Administrative approval is requested for the casing and tubing programs of Keel "A" No. 5, 7, and 14, Keel "B" No. 1, 2, 4, and 25, and West "B" No. 24 and 26 to water injection wells in the Keel-West Waterflood Project in the Grayburg Jackson Pool, Lea County, New Mexico.

In reference to our application of January 31, 1966, for approval of casing and tubing program on wells in the Keel-West Waterflood project, the State Engineer has requested additional information and clarification concerning our application.

With reference to your letter of February 9, 1966, requesting additional information and clarification of our application of January 31, 1966, for approval of the tubing and casing program on wells in the Keel-West Waterflood, we wish to first apologize for the inconvenience this has caused your office and staff.

Attached is a schematic of the proposed casing and tubing programs. If additional information is required, please advise.

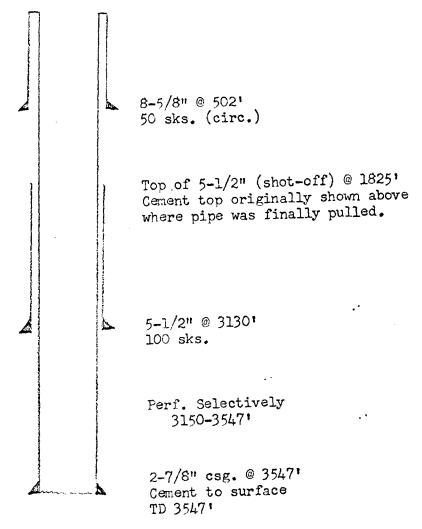
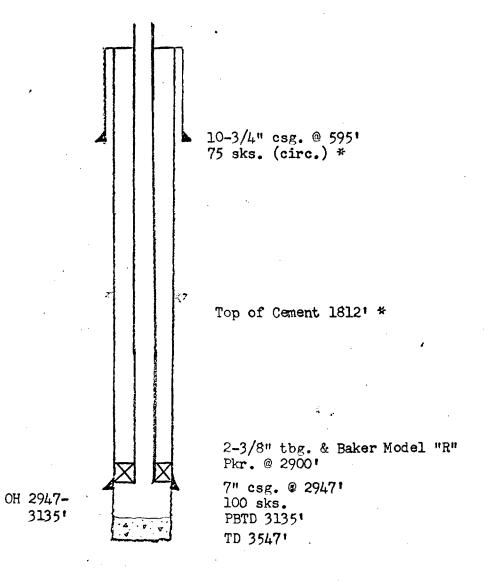
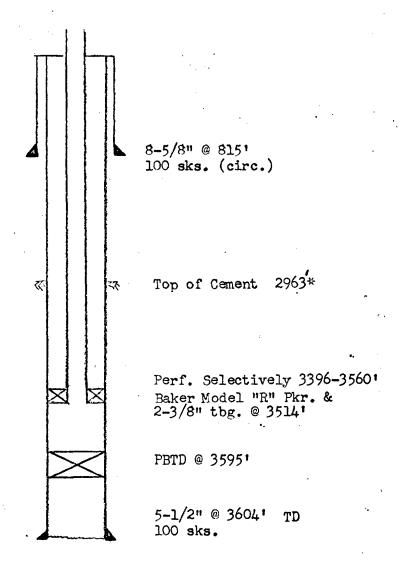
In answer to your question concerning the cement tops and determination thereof; these tops, with the exception of the cement top behind the producing string in the Keel "B" No. 4 and West "B" No. 26, were determined by personnel from another office. The information was previously shown on exhibits 4 and 5 in a hearing held before the Oil Conservation Commission on September 25, 1963. The case appeared on the docket as No. 2909. These exhibits also reflect the correct casing sizes of 8-5/8" and 7" casing on the Keel "A" No. 7 and Keel "B" No. 2. The cement top on the West "B" No. 26 was changed to more accurately reflect the well conditions and the Keel "B" No. 4's top was thru a typographical error. We again regret the ommission of the asterisk and the attached schematics reflect the true conditions.

The remedial work on the Keel "A" No. 5 has not been completed. It is calculated that approximately 700 sacks will be required to circulate the cement to surface. If the cement does not circulate, we propose to pump cement behind the 2-7/8" casing from the surface. The remedial work on Keel "B" No. 2 and No. 4 has not started; however, we normally use from 100 to 150 sacks of cement depending on the caliper survey and hole condition. Sufficient cement is used to circulate around the top of the liners. After drilling out, the liner top is tested and resqueezed if necessary. In regards to the West "B" No. 24, again this was an error and should have been 3314' rather than 3514'.

Attached is our letter of explanation and corrected schematic diagrams of the injection wells which we have this date forwarded to the State Engineer.

We are forwarding corrected schematics, with copy of this letter, to the Secretary Director of the New Mexico Oil Conservation Commission, and again request your approval of the casing and tubing program.
